CAA Operational Assessment

Title of airspace change proposal	NPAS BLVOS
Change sponsor	NPAS
Project reference	ACP-2024-035
Account Manager	
Case study commencement date	23 Apr 25
Case study report as at	02 July 25

Figure 4: The TDA outlined in red with 3 sectors. The Central Sector (1) shaded red, West Sector (2) shaded blue, and North Sector (3) shaded green. Displayed on a Google Earth background.

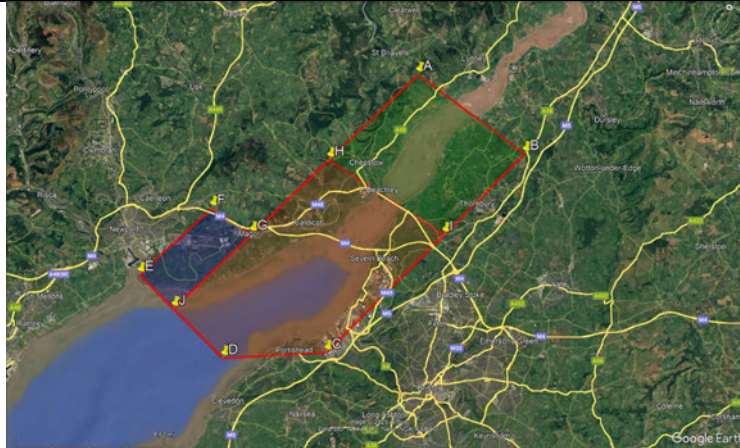
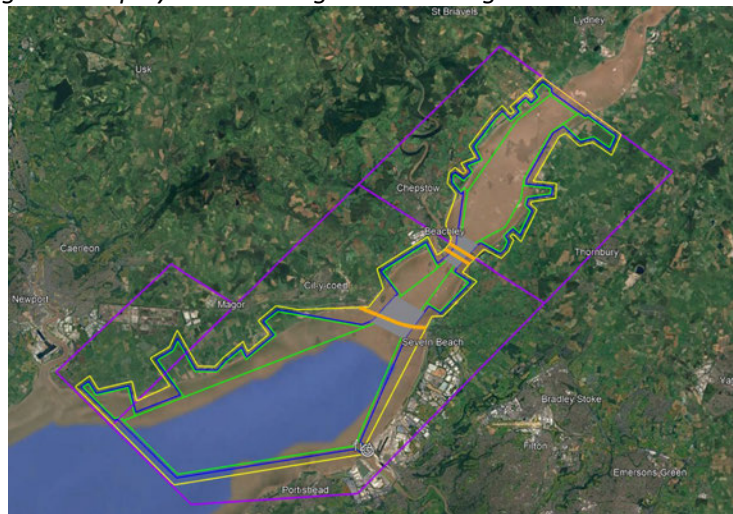
2.	Airspace description and operational arrangements	Status
2.1	Is the type of proposed airspace design clearly stated and understood?	PARTIALLY
	<p>The sponsor has clearly stated and described the proposed Temporary Danger Area (TDA), including its segmentation, activation procedures, and operational context.</p> <p>However, the sponsor has not provided any technical airspace design principals justification for the airspace dimensions. The operational volume shown in Figure 5 is significantly smaller than the full TDA boundary shown in Figure 4, and no evidence has been provided to demonstrate that the UAS requires the full extent of the requested airspace. This is inconsistent with the requirements of SARG Policy 133 section 5.6, which essentially states that SUA must be “as small as practicable” and based on the requirements of the activity.</p>

UPDATE 16th June 2025** Sponsor has provided an Updated ACP V4.0 which has provided sufficient rationale for the proposed airspace structure.	
2.2	Are the hours of operation of the airspace and any seasonal variations stated and acceptable?	YES
	The sponsor has clearly stated the hours of operation for the proposed Temporary Danger Area (TDA), which will be active Monday to Friday from 22:00 to 04:00 local time between 03 July and 01 October 2025. These hours are fixed, the justification for nighttime only operations is proportionate, aiming to minimise disruption to other airspace users. Stakeholder feedback confirms that the proposed hours are broadly acceptable, with no significant objections raised in relation to nighttime operations. The proposed hours meet the requirements of CAP1616g, section 4.8 and SARG Policy 133, section 5.6(c).

2.19	Is the airspace structure designed to ensure that adequate and appropriate terrain clearance can be readily applied within and adjacent to the proposed airspace?	PARTIALLY
	The sponsor has not provided any terrain clearance analysis or evidence within the ACP. However, based on Figure 5 in Q2.1 the intended operational volume the UA operates limited over land and the sponsor highlighted two bridges where the UA will transit over the estuary between 900 – 1050 ft.
